Access Compliance Report

Public Rights-of-Way

(Curb Ramps)

Intersection ID: 18387	Main Street: BURTONWOOD_CR	Cross Street: MONROE_RD	Location: NW
ADA ID: E02BB2079D87	Ramp Type: PerpDiag	Initial Pass/Fail: Fail	Overall Compliance: No
Codes/Mitigation Info/Possible Solution		Field Measurements/Component Compliance

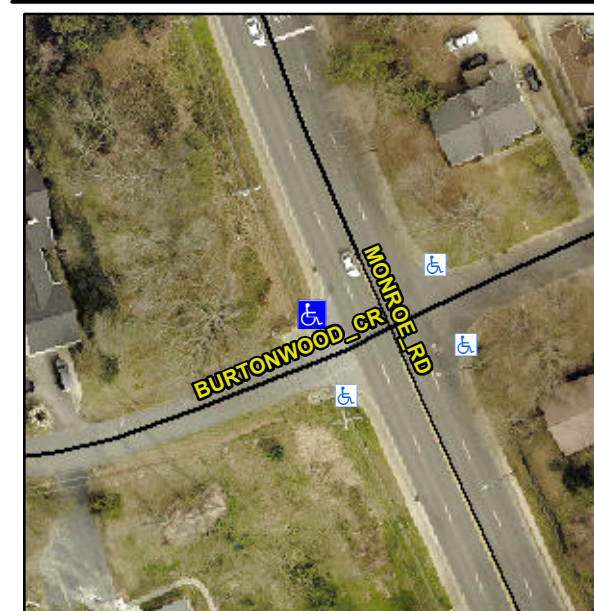
Not Found, R304.2.2, R304.5.3

Compliance	Description	Data	Compliance	Description	Data
N/A	Ramp Length (in)	60.0	No	Ramp Slope (%)	11.8
Yes	Ramp Width (in)	48.0	No	Ramp XSlope (%)	4.9
N/A	Flare Type LT	N/A	N/A	Flare Type RT	N/A
N/A	Flare Slope LT (%)	N/A	N/A	Flare Slope RT (%)	N/A
N/A	Flare Traversable LT?	N/A	N/A	Flare Traversable RT?	N/A
N/A	Landing Length (in)	N/A	N/A	DWS Provided?	N/A
N/A	Landing Width (in)	N/A	N/A	DWS Contrast?	N/A
N/A	Landing Slope (%)	N/A	N/A	DWS Length (in)	N/A
N/A	Landing X Slope (%)	N/A	N/A	DWS Full Width?	N/A
N/A	Landing Curb? (Y/N)	N/A	N/A	DWS Offset (in)	N/A
N/A	Shared Landing?	N/A			
N/A	Gutter Ponding?	N/A	N/A	Gutter Slope (%)	N/A
N/A	Gutter Lip Ht (in)	N/A	N/A	Gutter X Slope (%)	N/A
N/A	Painted X Walk1?	No	N/A	Painted X Walk2?	No
	X Walk 1 Direction	To S		X Walk 2 Direction	To E
N/A	X Walk 1 Width (in)	N/A	N/A	X Walk 2 Width (in)	N/A
	X Walk 1 Slope (%)	1.2		X Walk 2 Slope (%)	3.6
	X Walk 1 X Slope (%)	3.4		X Walk 2 X Slope (%)	3.1

Remove & Replace Curb Ramp With Two New Directional Ramps or Equivalent.
